From: Falk, John
Sent: Thursday, March 22, 2012 8:05 AM
To: Hemenway, Sandy
Cc: Peppersack, Jeff; Saxton, Craig
Subject: RE: 79-7254 Allen (current owner), Dam: 12 ft height embankment, 1.68 acre X 8 ft deep, 13.4 af

From: Hemenway, Sandy
Sent: Wednesday, March 21, 2012 3:11 PM
To: Falk, John
Cc: Hemenway, Sandy
Subject: 79-7254 Allen (current owner), Dam: 12 ft height embankment, 1.68 acre X 8 ft deep, 13.4 af

Effective Height	5 ft
Maximum Fill Height	7 ft.
Length	460 ft.
Estimated Water Storage	8 acre feet
Estimated Fill	1040 cubic yards
NRCS Engineering Job Class II

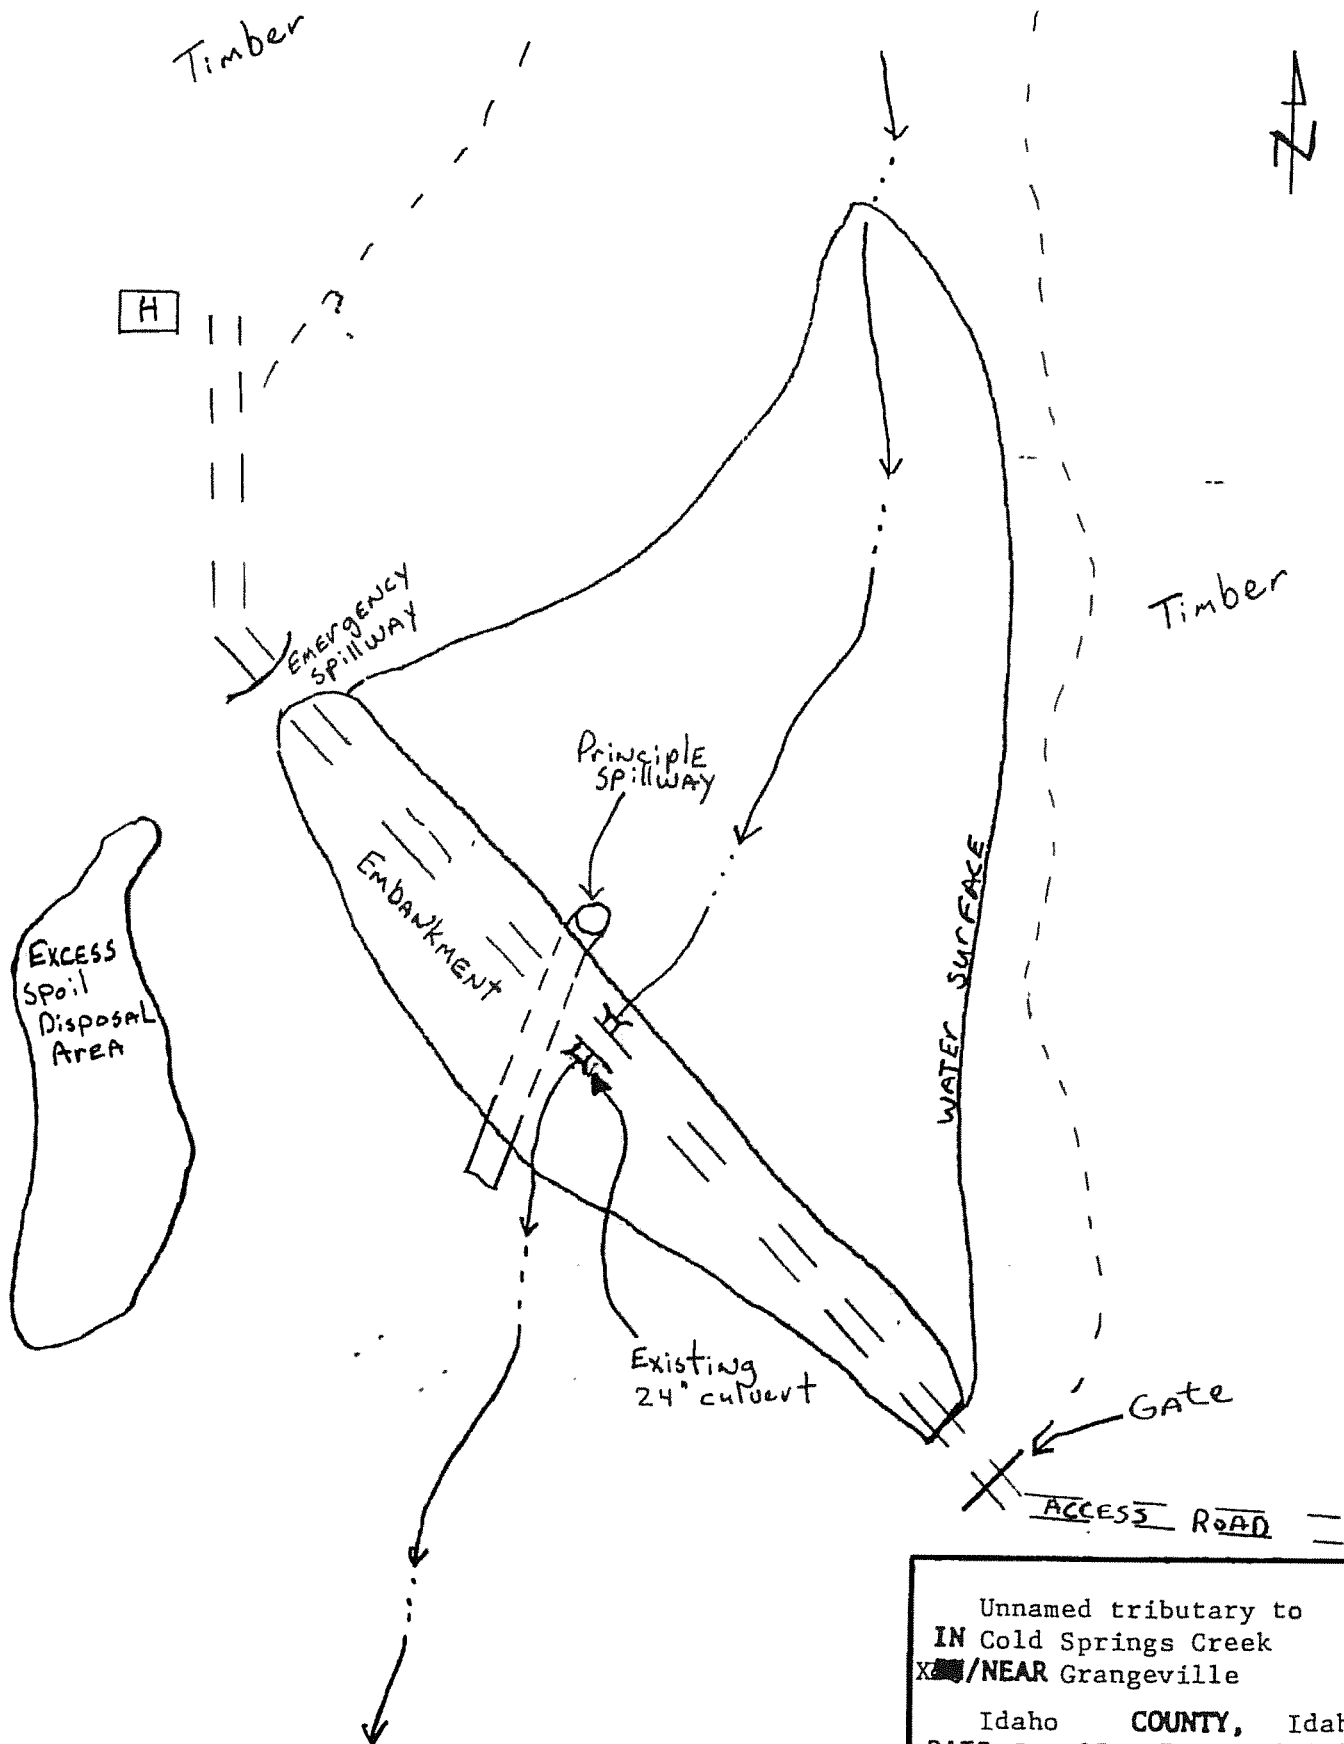
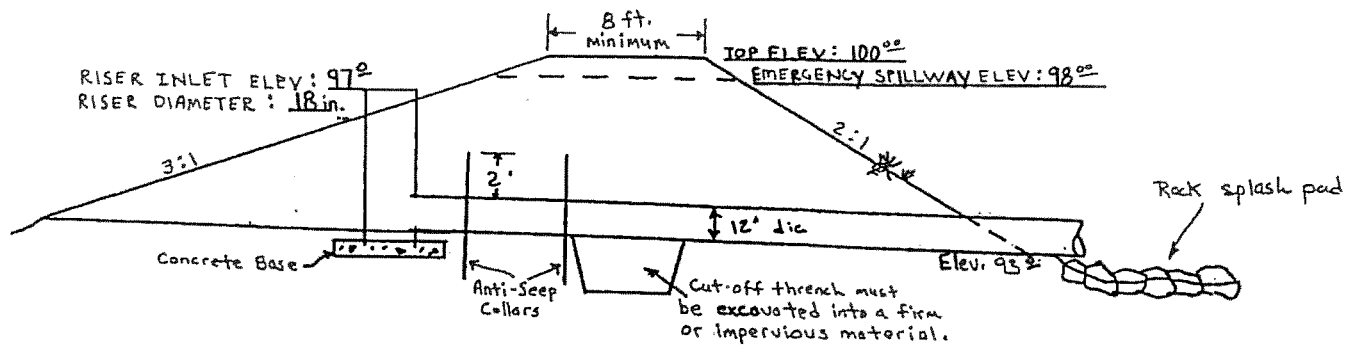
If in fact the dam is 12' high and impounds 13.4 acre-feet of water, then the enlarged structure superimposed on original design (attached) doesn't meet IDWR dam standards listed in the Rules (36.03.06). Because it is already constructed our options are limited to: a) remove, b) reduce height to match original design, c) require the owner to submit additional information and thus bring the structure into compliance.

1. Apparently IDWR did not receive an *Application for Construction of a Dam* and the requisite fee; this can be required of the owner, together with a set of asbuilt drawings addressing minimum standards detailed in the Rules.
2. The downstream hazard potential has not been assessed. Because it's a small dam, it probably is a Low hazard structure but IDWR should verify before signing off on this one.

A final option for the owner would be to hire a licensed engineer/surveyor/CWRE to contest the amount of storage impounded by the dam. For example, the actual volume is probably some fraction (50-60%) of SA (1.68 acres) x Depth (8'). Instead of 13.4 ac-ft, it may only be 7-to-8 ac-ft. And, if storage is less than 10, then structure is exempt from IDWR dam safety regulation, assuming of course that the Low hazard classification is valid.
